Mapleton City Planning Commission Staff Report

Bruce Rees requests Final Plat approval of Breckenridge Lane Subdivision, Plat "A" (9 lots proposed), on property located generally at 1000 West 1600 South. The subject property is located in the RA-1 (Residential Agricultural) Zone.

MAPLETON CITY DEVELOPMENT REVIEW COMMITTEE MINUTES

BRECKENRIDGE LANE SUBDIVISION
PLAT "A"

(MODIFIED) TYPICAL 56' SECTION
MAPLETON CITY STANDARD DRAWING S-01 (MODIFIED)
1000 WEST STREET
1200 SOUTH STREET
-NTS-

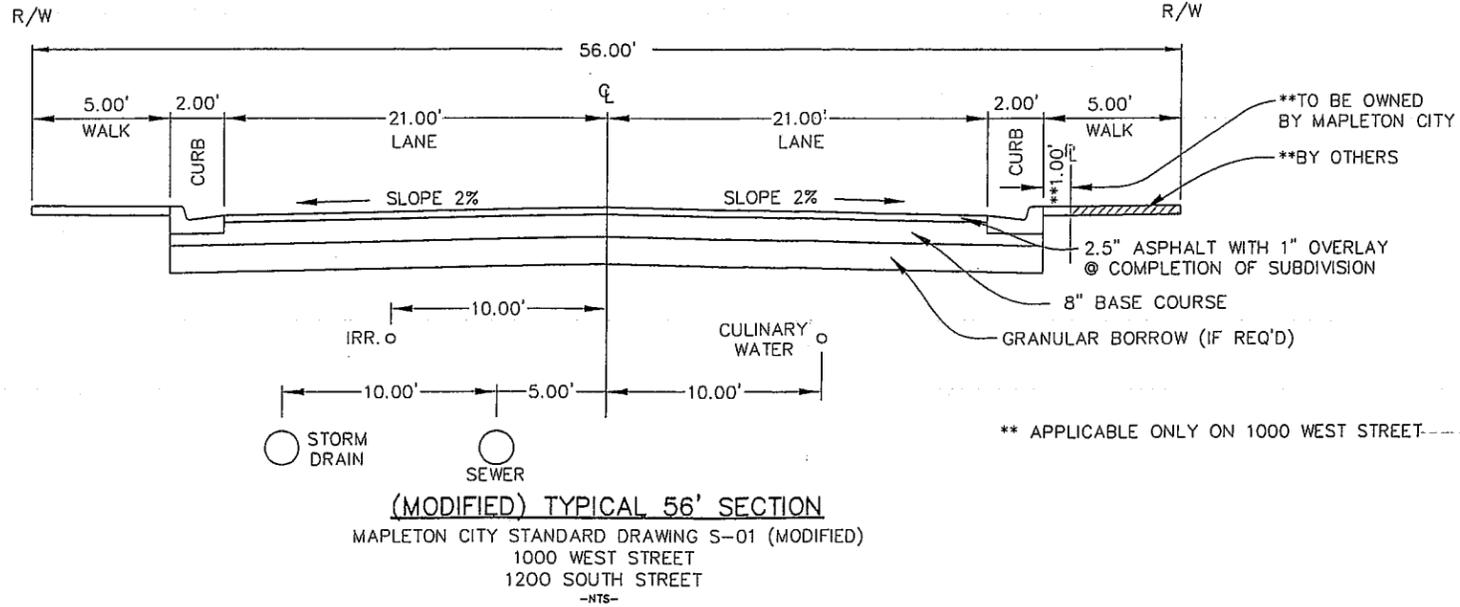
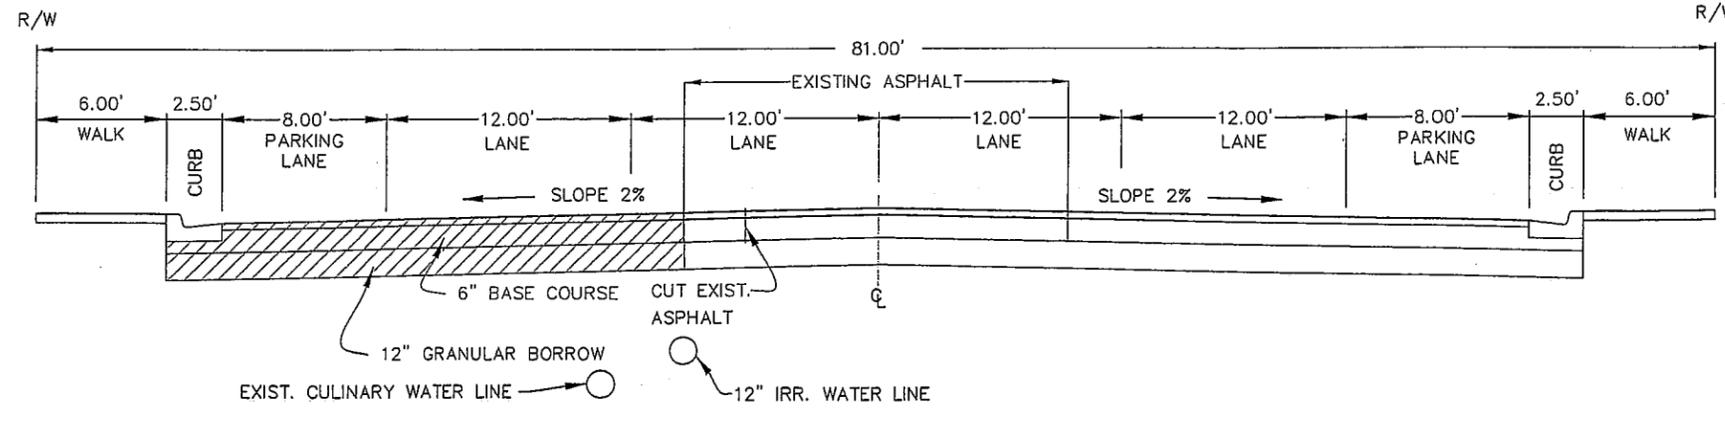
1. Temporary turnaround needs a legal description.
2. Roadway cross sections state "granular borrow if required" – Granular borrow **will be required on all roadway cross sections.**
